SITE SUPPLEMENTAL INSTRUCTION

PROJECT: Forestside Estates
Attmar & Palleschi Drive
Brampton, ON

SITE SI NO. M-1

PURPOSE: To revise mechanical layout to suit architectural CS drawing and City comments for P1 level.

DRAWN	CHECKED	SCALE
MC	LM	1:150
DATE	PROJECT	DRAWING
MAY, 2019	18-017	M-2
		OF

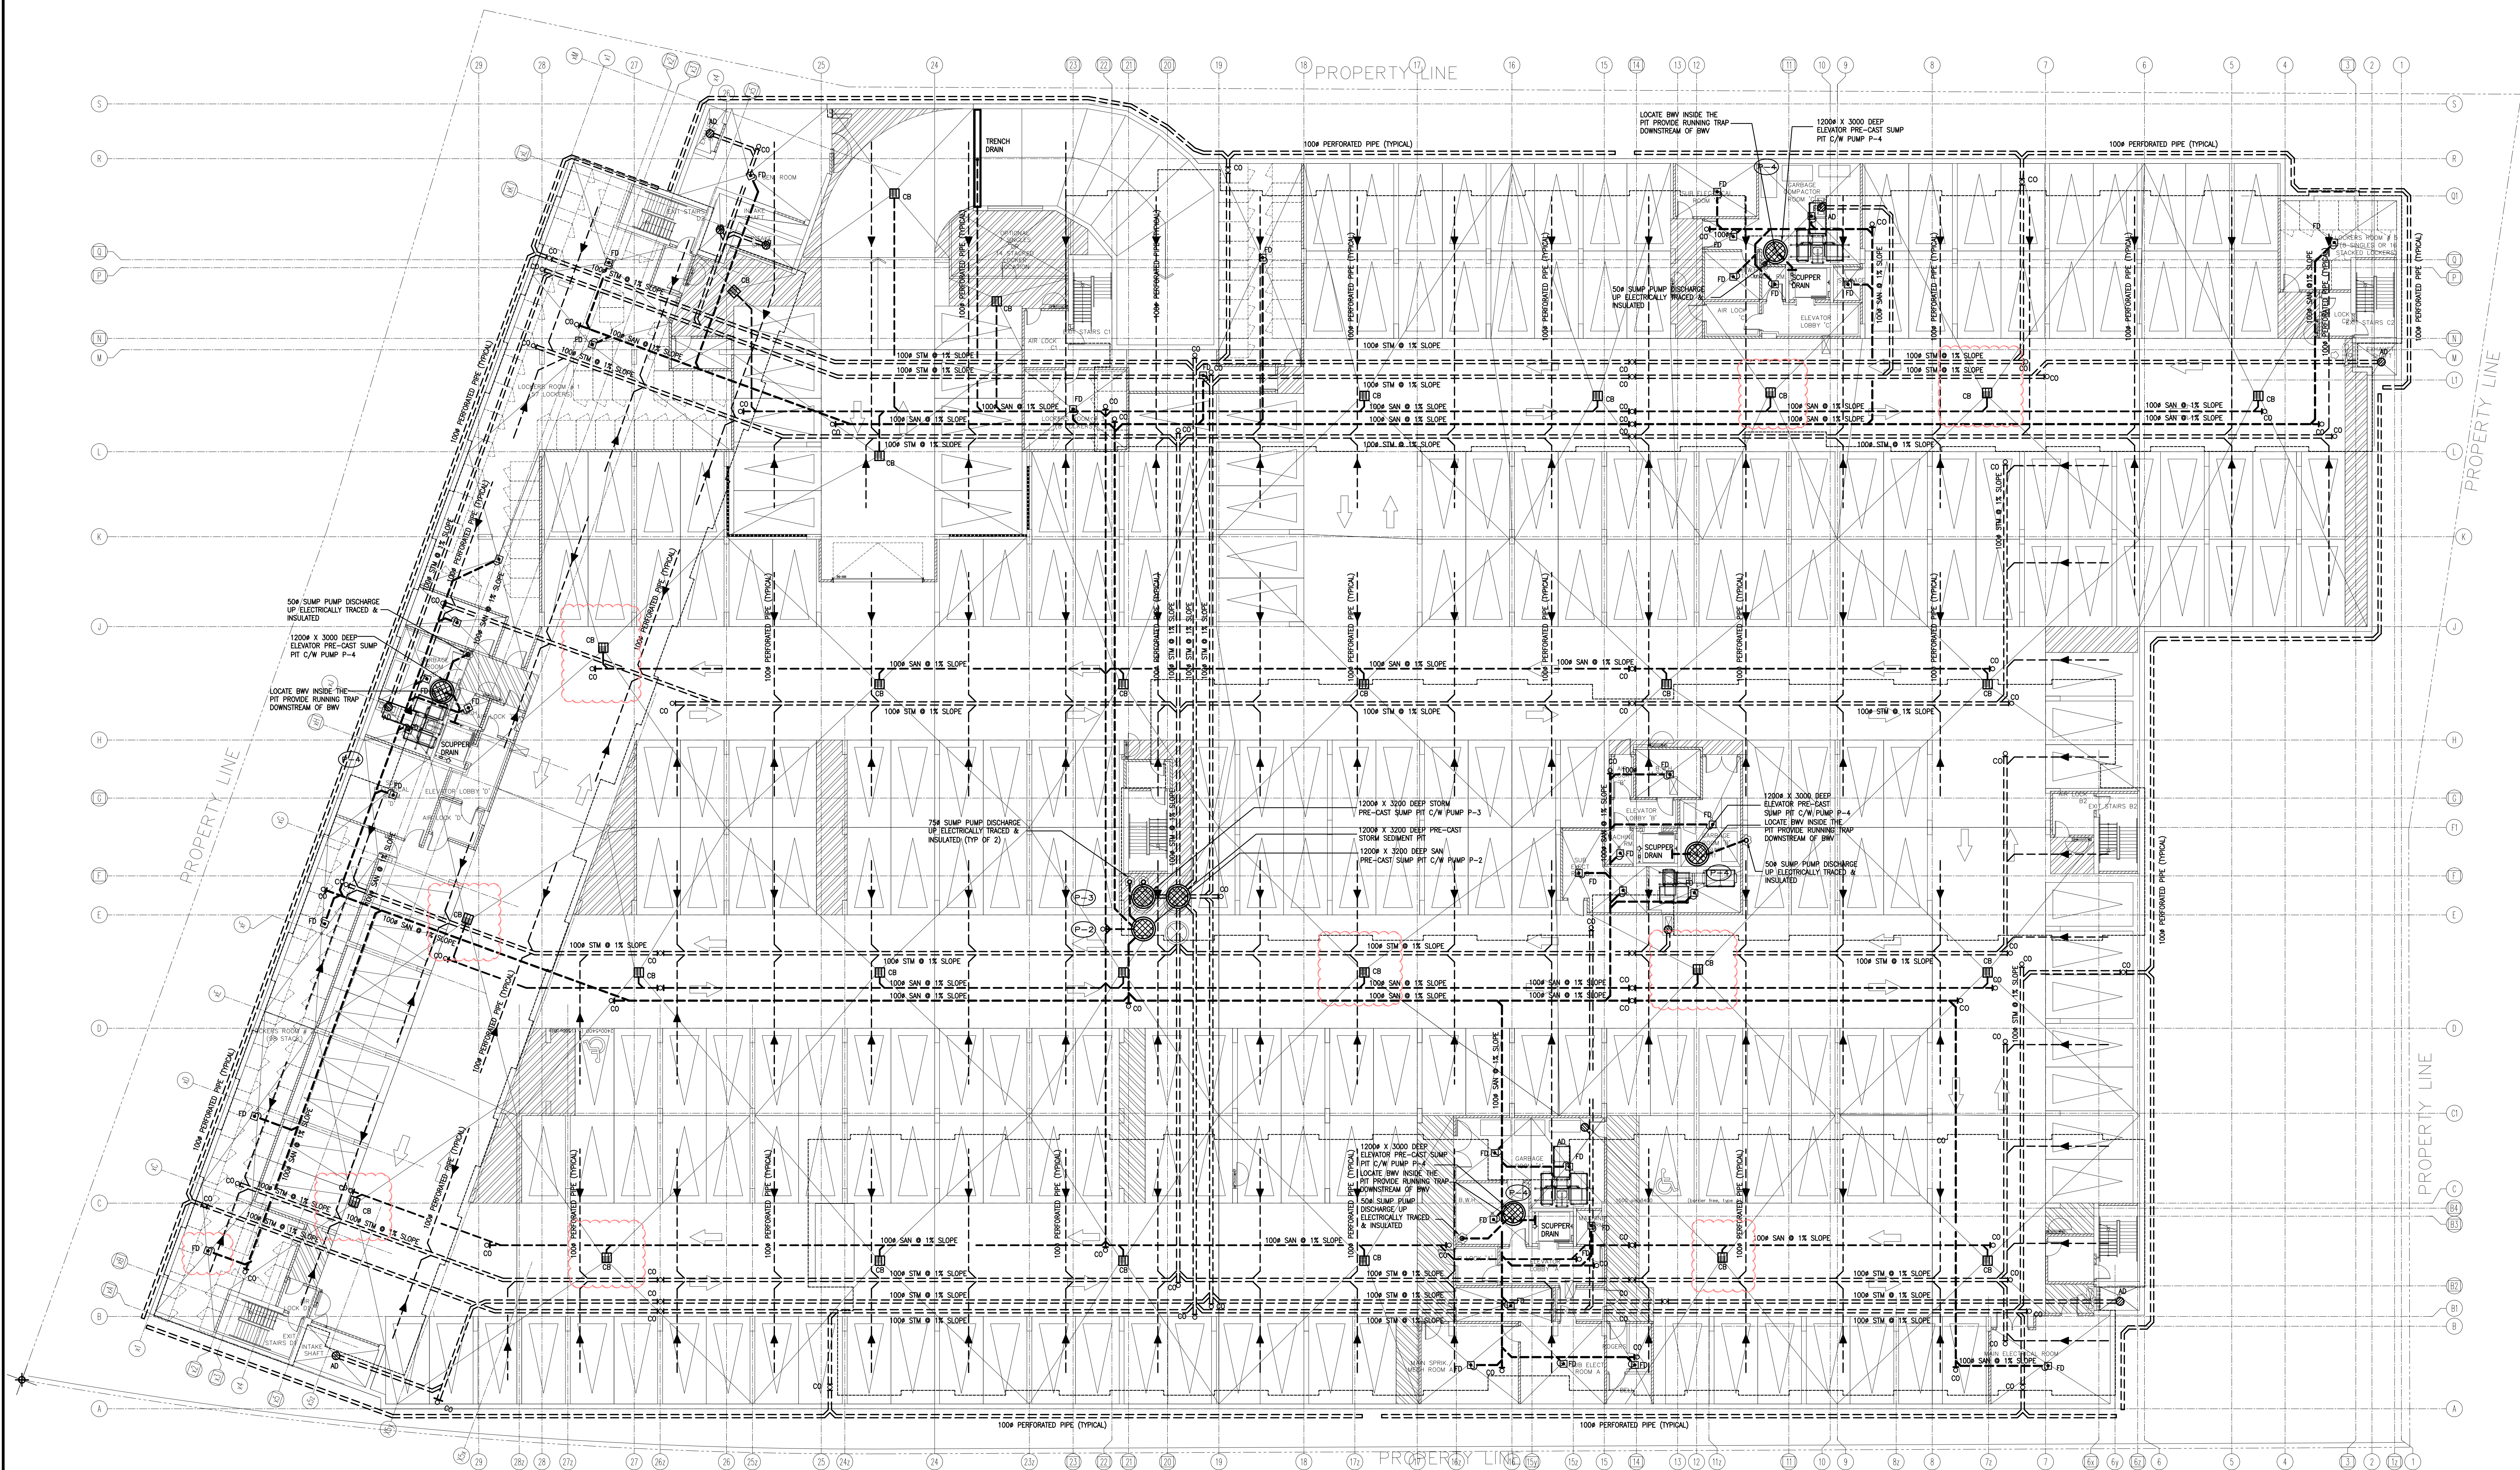
2.0 Reference Drawing M-2, M-2A, M-2B (Underground Drainage - Mechanical) Issued

2.1 Revised: Location of Catch Basins and floor drains.

TITLE PARKING LEVEL - PLUMBING MECHANICAL		
PROJECT BRAMPTON STACKED FORESTSIDE ESTATES		
ATTMAR + PALLESCHI DRIVE BRAMPTON, ONTARIO		
DRAWN MC	CHECKED LM	SCALE 1:150
DATE MAY, 2019	PROJECT 18-017	DRAWING M-3
		OF -

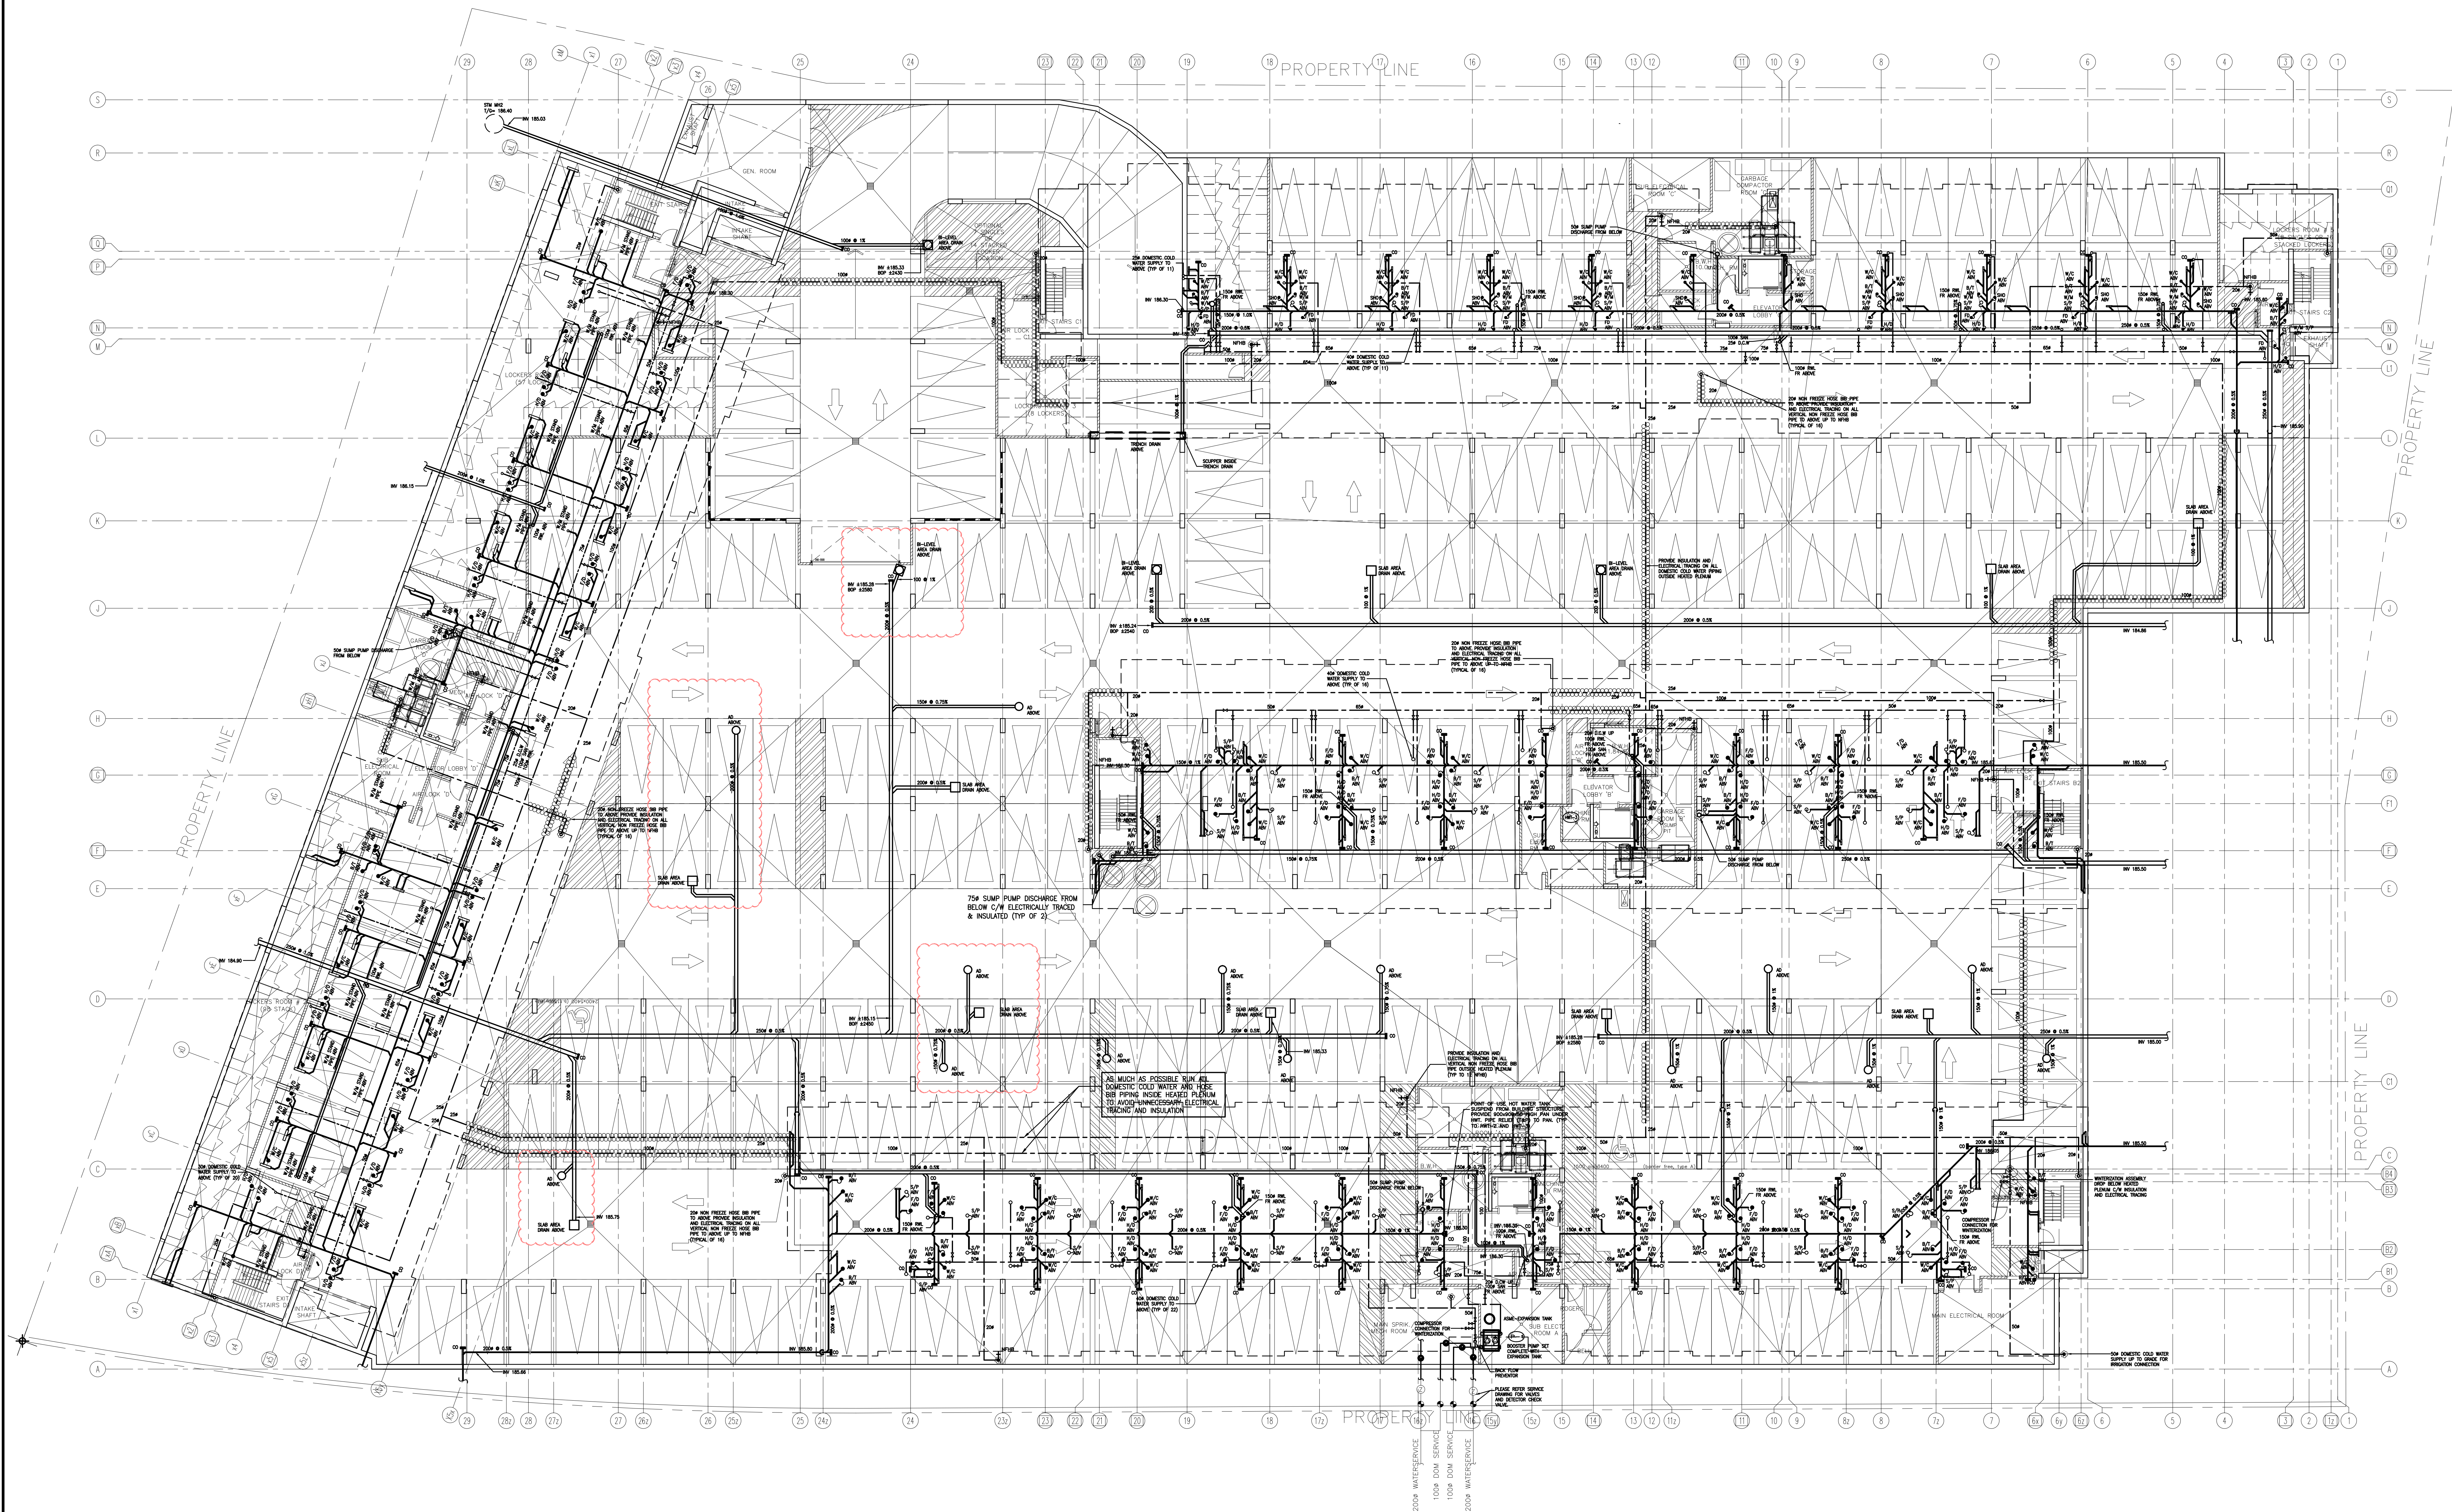
3.0 Reference Drawing M-3, M-3A, M-3B (Underground Drainage - Mechanical) Issued

3.1 Revised: Mechanical layout to pick up ground floor area drains and slab drains.
